ADDENDUM NUMBER TWO

RFQ # 7535371

TITLE: Construction of a New Fixed Pier and Dredging at Ft. Adams

NOTICE OF ADDENDUM NUMBER ONE (1)

SITE INFRASTRUCTURE IMPROVEMENTS
PROPOSED NEW PIER
GENERAL ARRANGEMENT DRAWING
SHEET 3 OF 3
FORT ADAMS STATE PARK, NEWPORT, RHODE ISLAND

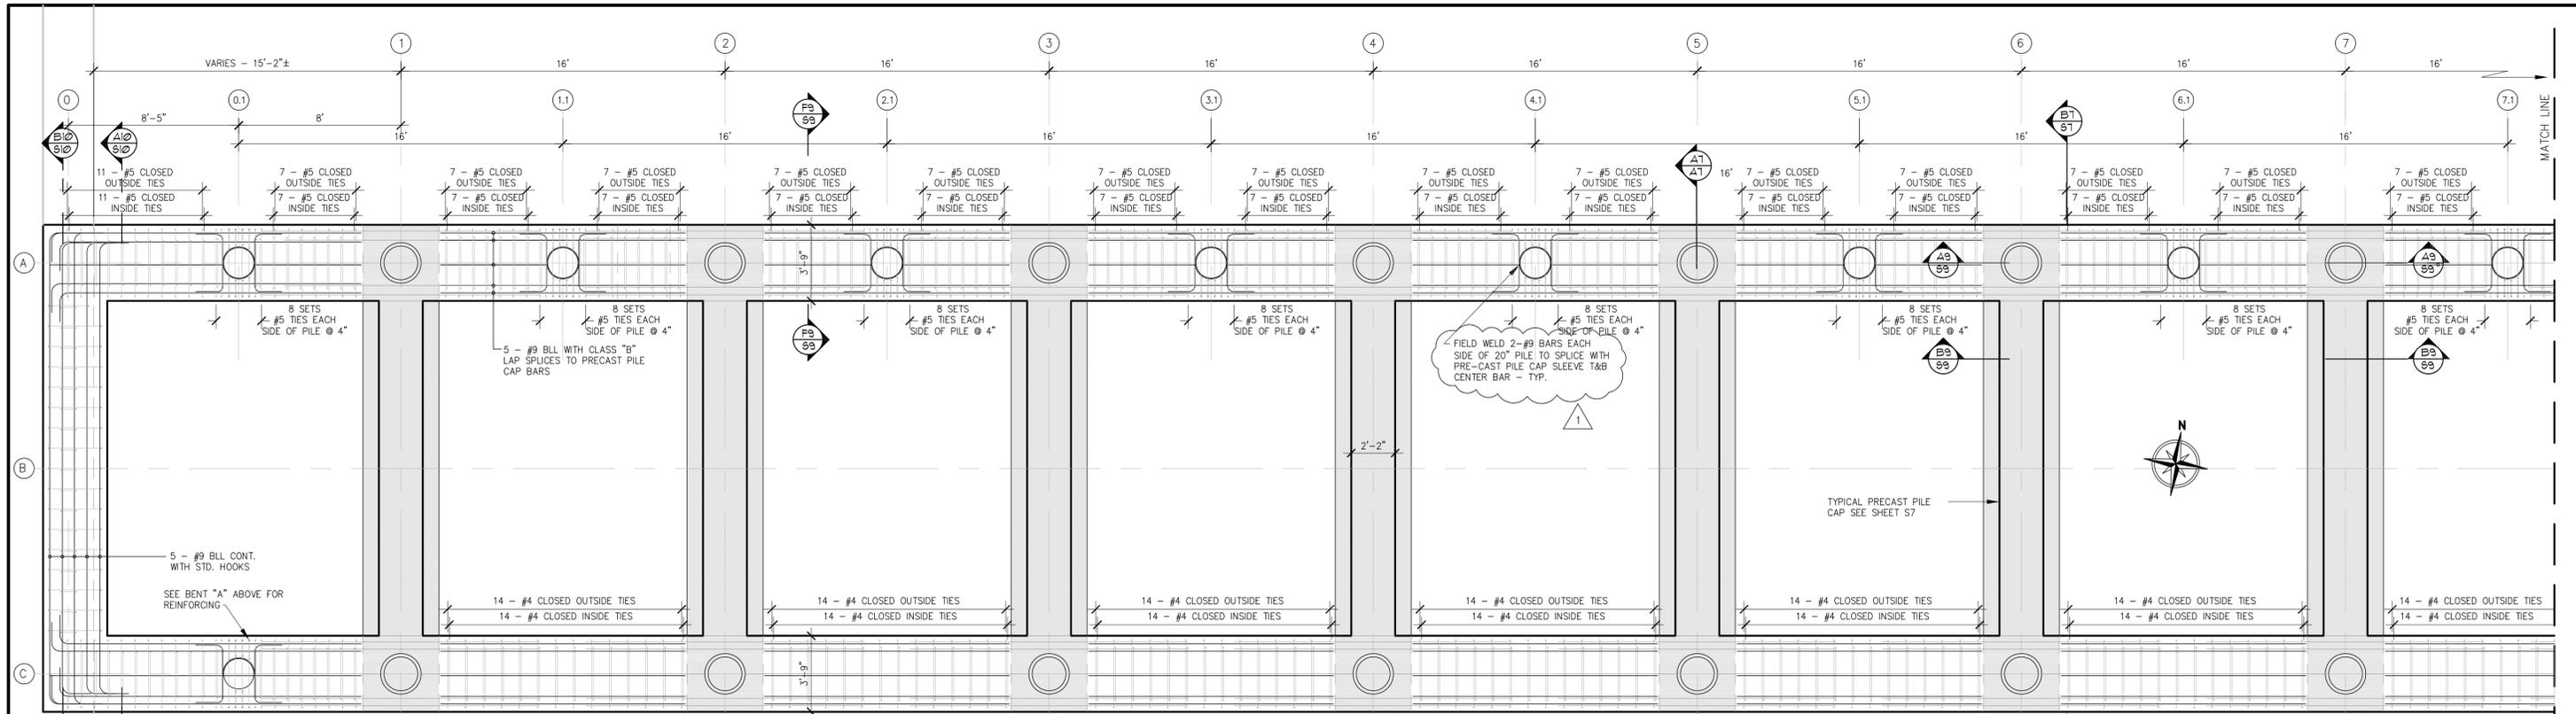
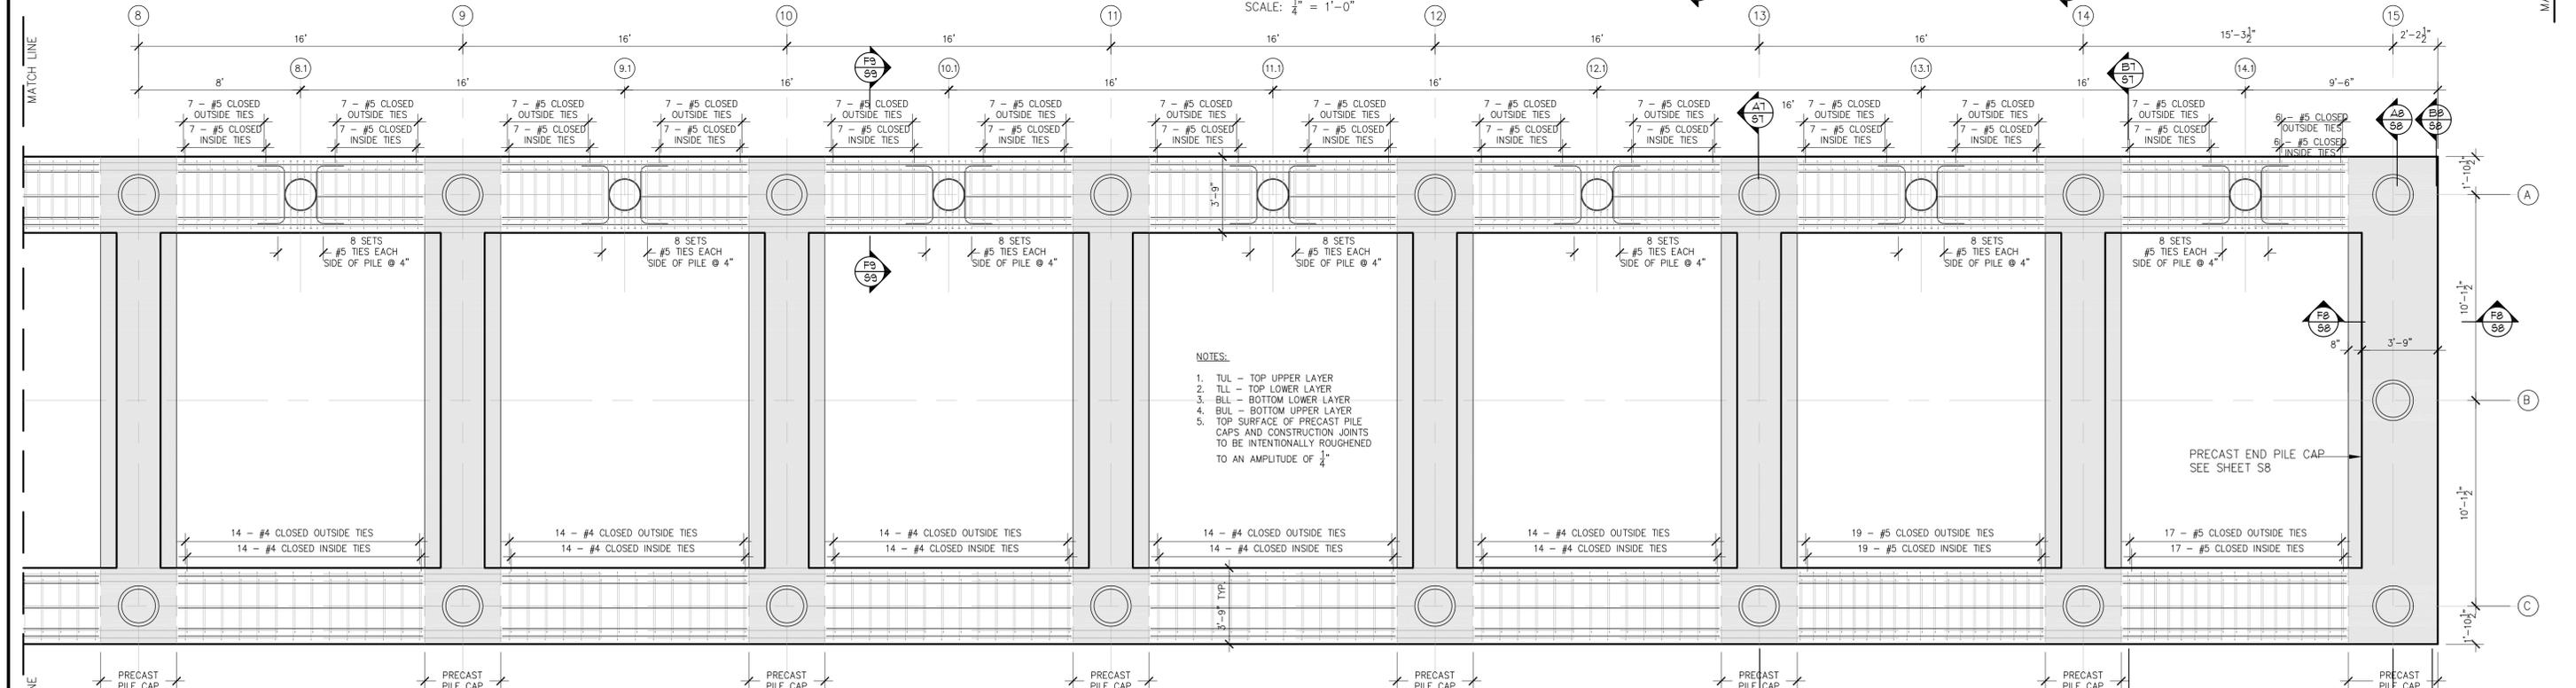
23. There are no details provided for the Platform at the top of the Gangway. Drawing S2 would indicate that your intent is that the platform be constructed from timber framing. Please clarify.

36. Provide clarification of the connection between the fixed pier and landing.

Sheet S4 has been revised to show the framing requirements for the gangway platform. Please see Addendum No. 1, Item 12.

Drawing S4 has been revised to provide details for the gangway landing. Please see Addendum No. 1, Item 12.

RIDEM PROJ. No. P&D 14-13
 OF **S6** SHEET **33**

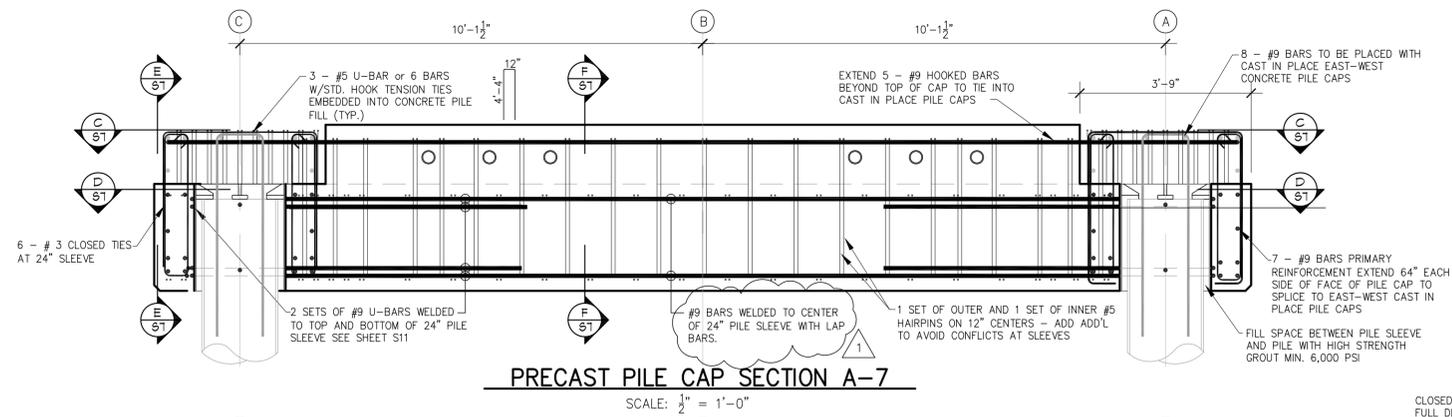
45. Drawing S6 calls for a "BUU" layer of 2 each #9's – please clarify nomenclature and confirm quantity (Sections E-9 and F-9 appear to show 4 bars).

Delete note "2 - #9 BUU - SEE SECTION E-8/S8 FOR ADD'L SIDE BARS". Refer to sheet S9 for reinforcing requirements. Please see Addendum No. 1, Item 13.

PRECAST PILE CAP SECTION A-7

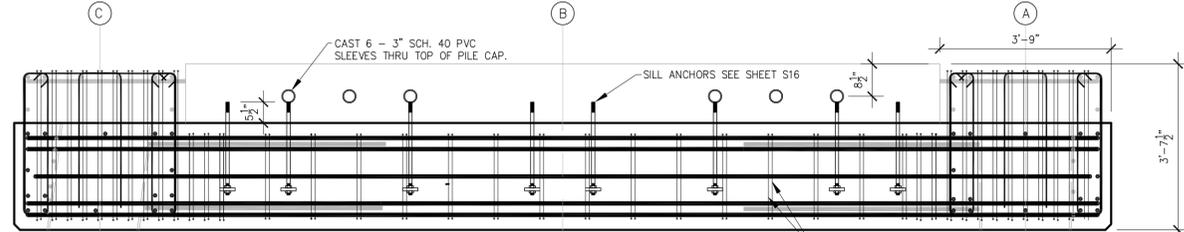
46. Section A-7 on Sheet S7 calls for "#9 BARS WELDED TO CENTER OF 24" PILE SLEEVE" top and bottom. Are these bars spliced to the bars attached by welding to the prefabricated pile sleeve (Sheet S11), or are they welded to the sleeve in addition to the welded bars shown on Sheet S11.

A straight bar may be lap spliced to the center bars that are welded to pipe sleeves to provide continuation of the reinforcing across the pile cap. It is not intended that additional bars be welded to the pipe sleeves.

PRECAST PILE CAP SECTION C-7

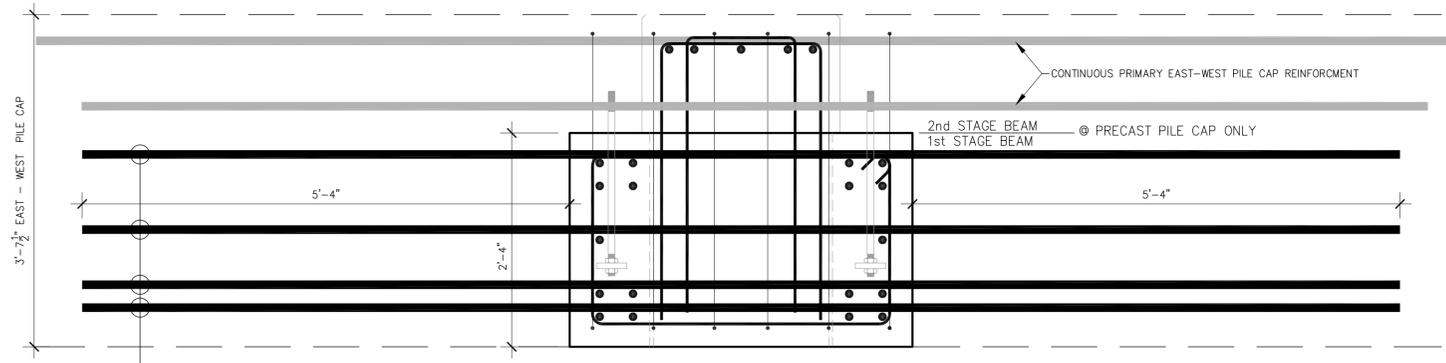
50. Note on Drawing S7 (Section C-7) calls for "FIELD PLACE EAST WEST REINFORCEMENT DURING CONSTRUCTION OF PILE CAPS ALONG A & C BENTS." Section C-7 also calls for the #9 top steel to be continuous. This would indicate that these bars are not spliced. Please review.

Standard splices in accordance with the notes on Sheet S1 are acceptable in placing continuous bars.

PRECAST PILE CAP SECTION D-8

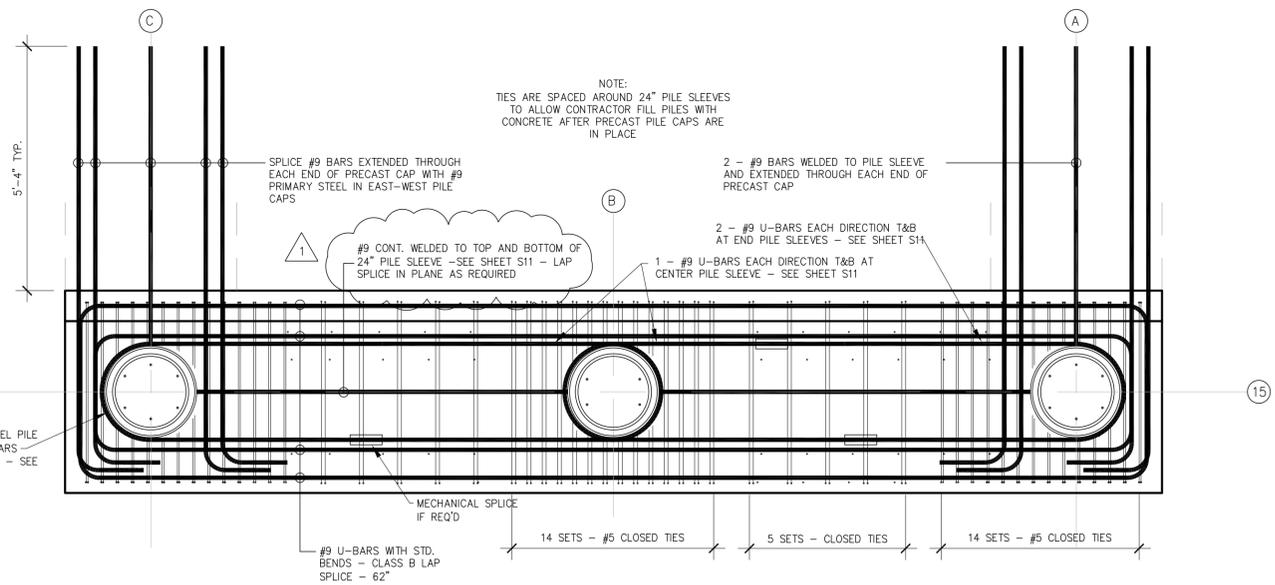
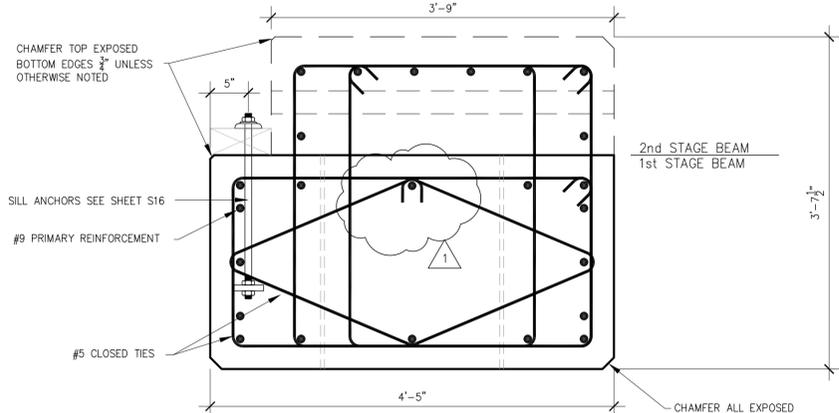
14. For the Pipe Pile Sleeve located in the center (Line B) of Precast Pile Cap 15 (Sheet S8), please confirm that 2 each #9 reinforcing is to be shop welded to both sides of the Sleeve (Sheet S9 calls for a #8 bar)

15. With reference to Section D-8 on Sheet S8, is the #9 reinforcing shop welded to the Line A and Line C Sleeves independent of the #9 reinforcing shop welded to the Line B Sleeve (this should be the case since neither weld is called out as a Field Weld).

Sheet S8 details pile cap 15. Sheet S9 details intermediate east-west field cast pile caps (0.1 to 14.1) along the north face of the pier. There are no sleeves at piles located between the major pile bents (1 to 15). It is intended that the #8 U-bars shown on Sheet S9 and the #9 center bars top and bottom (running east west) be field welded after the piles are driven and cut off, prior to casting in place the concrete.

CAST-IN-PLACE PILE CAP SECTION D-9
SCALE: 1/2" = 1'-0"

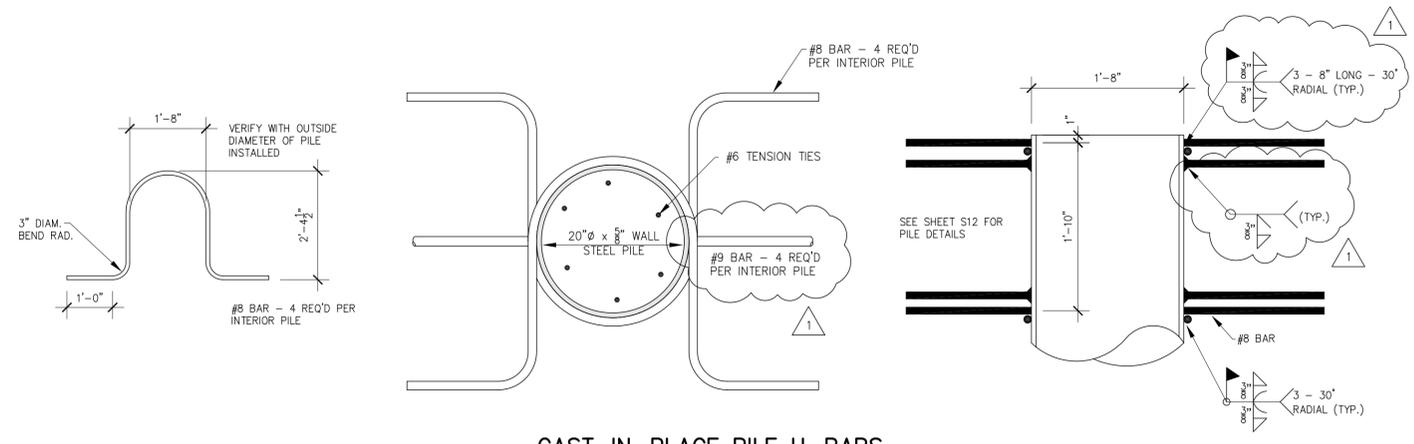
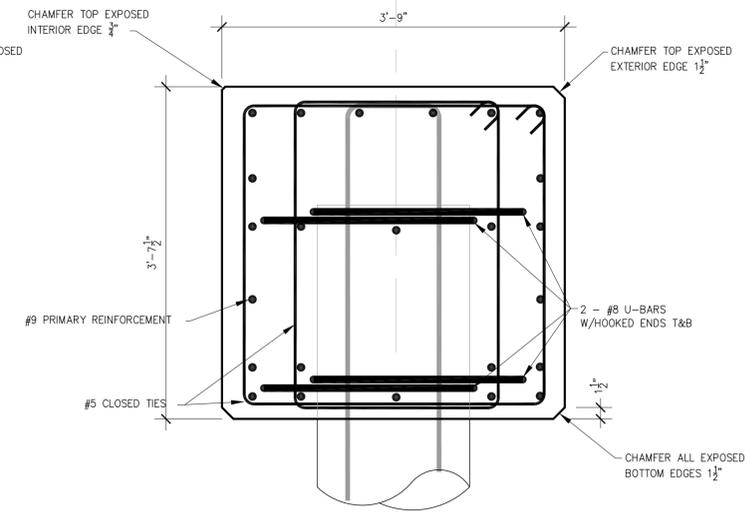
17. Section D-9 on Sheet S9 calls for 18" Pile - please clarify

Please see Addendum No. 1, Item 16. All piles are 20" in diameter. Sheet S9 has been revised to correct this error.

**SECTION THRU CENTERLINE
PILE SLEEVE PILE BENT LINE "15-B"**

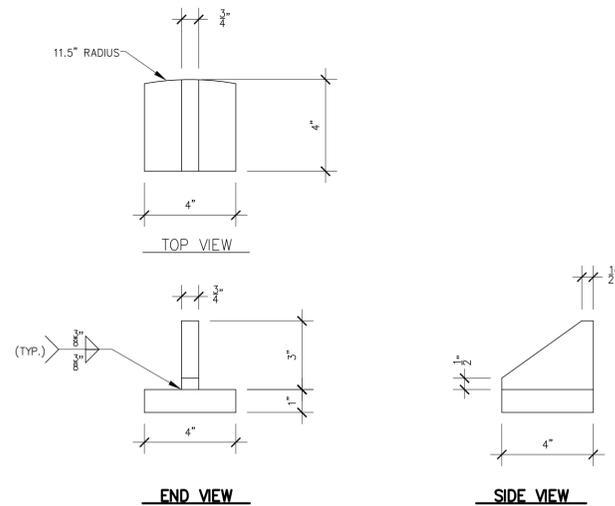
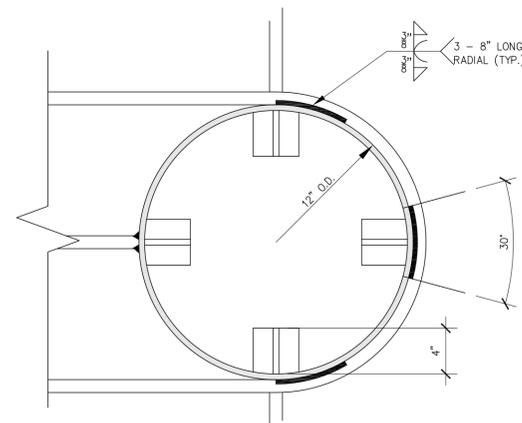
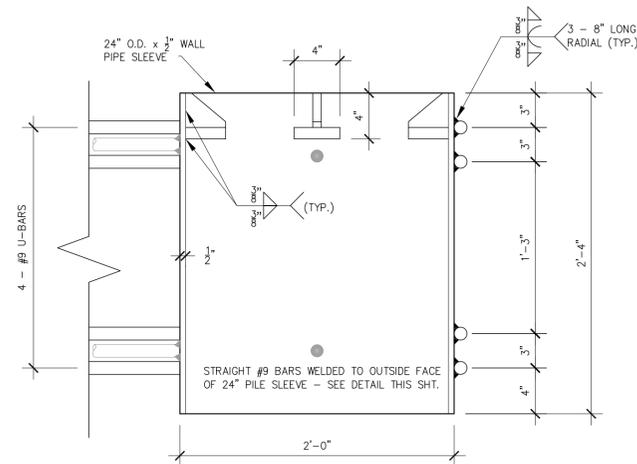
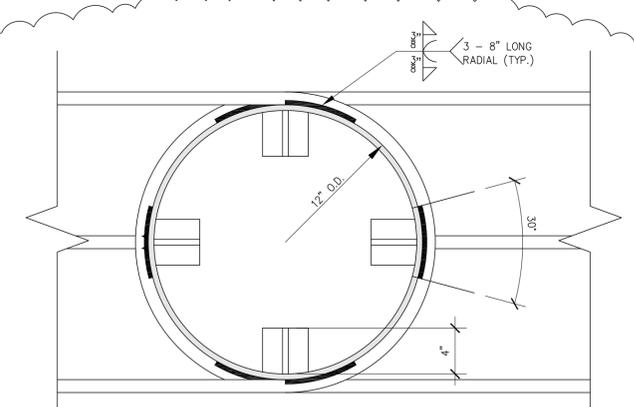
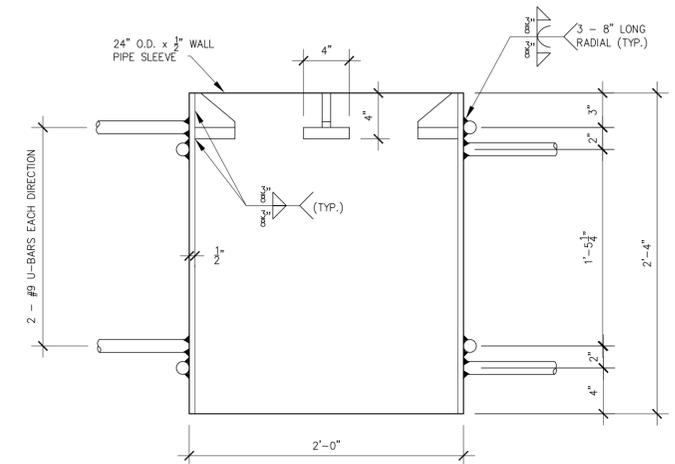
48. Section D-8 shows the reinforcing steel at Bent 15. What are the reinforcing steel fabrication details for the center Pipe Sleeve (not shown on Sheet S11).

A detail has been added to Sheet S11 detailing the center pile sleeve. Please see Addendum No. 1, Item 18.

SITE INFRASTRUCTURE IMPROVEMENTS
PROPOSED NEW PIER BEARING PILE LAYOUT
FORT ADAMS STATE PARK, NEWPORT, RHODE ISLAND

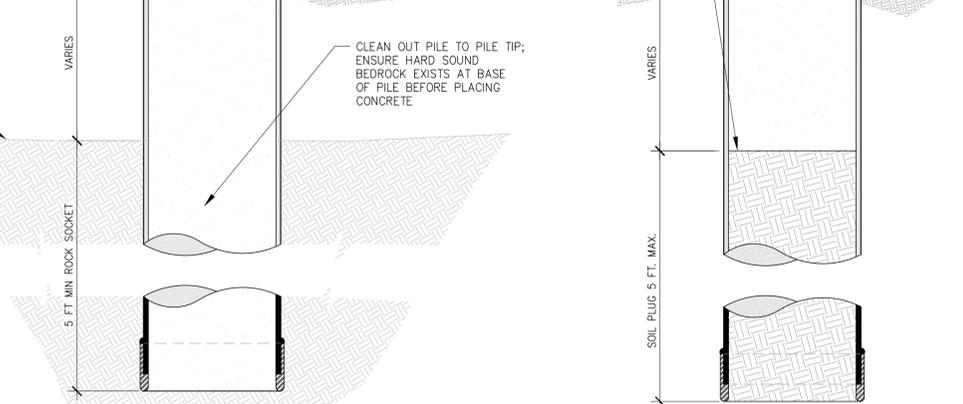
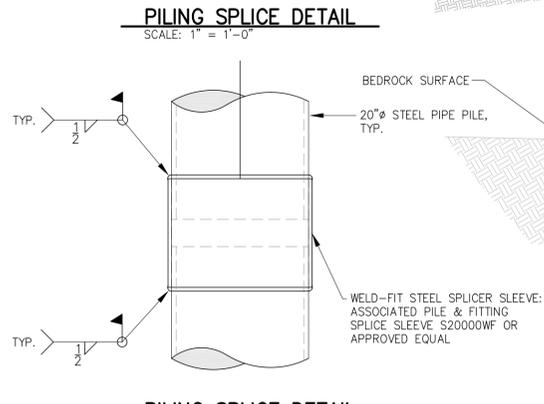
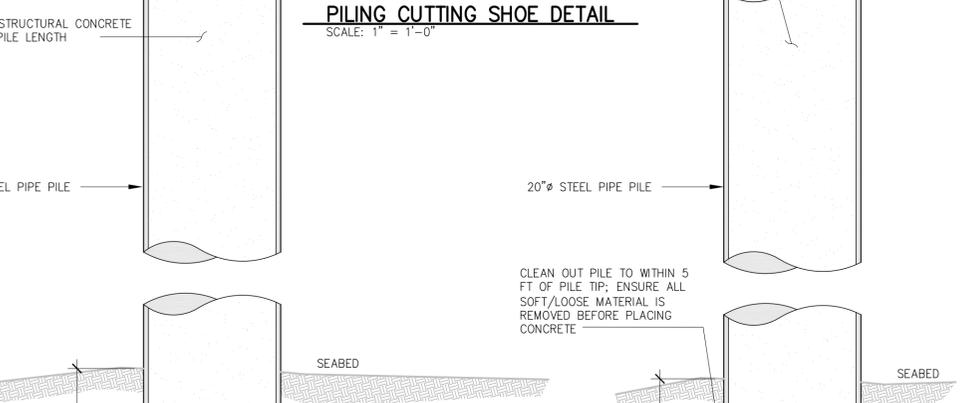
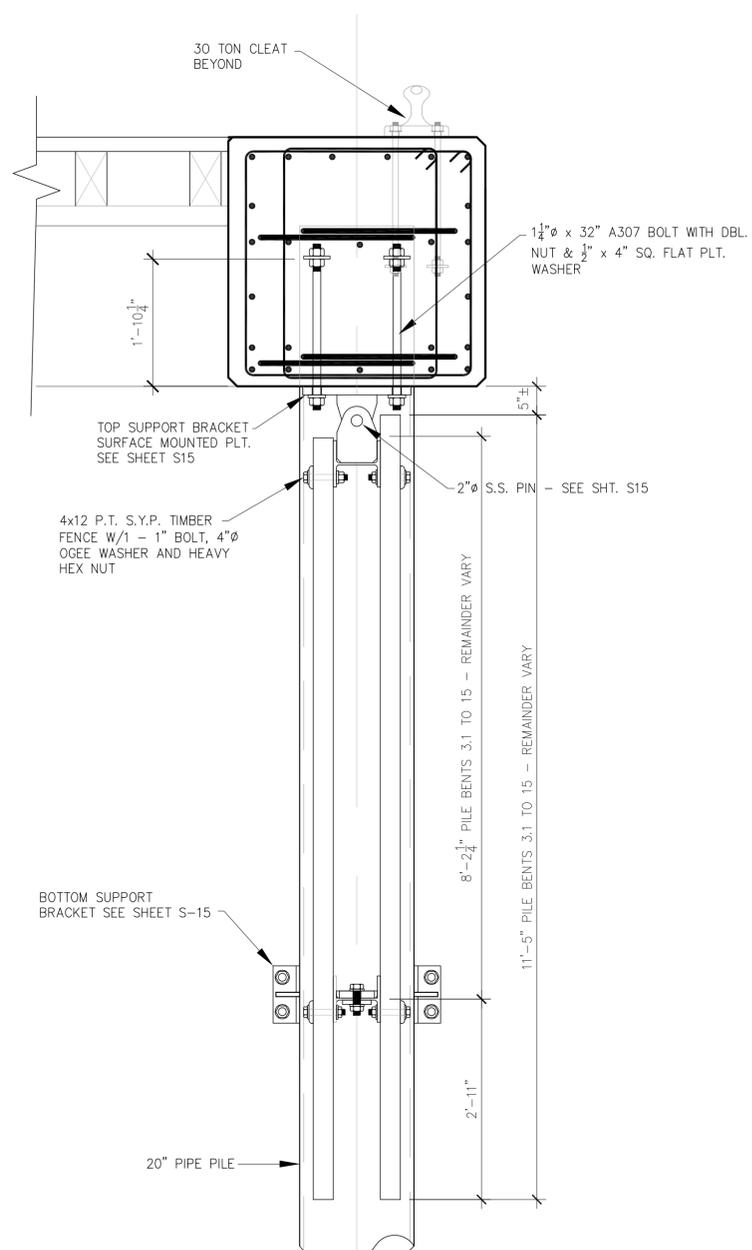
2. Please review the Seabed Elevation provided for Pile B15 (Sheet S12)

7. For the Pier Bearing Piles, is the "Estimated Tip Elevation" (Sheet S12) synonymous with the "minimum tip elevation" (Pile Spec Page 6)?

Please see Addendum No. 1, Item 19. The table has been revised, accordingly.

Yes, the minimum tip elevation (Section 02363, paragraph 3.3.D) is synonymous with the estimated tip elevation (Sheet S-12).
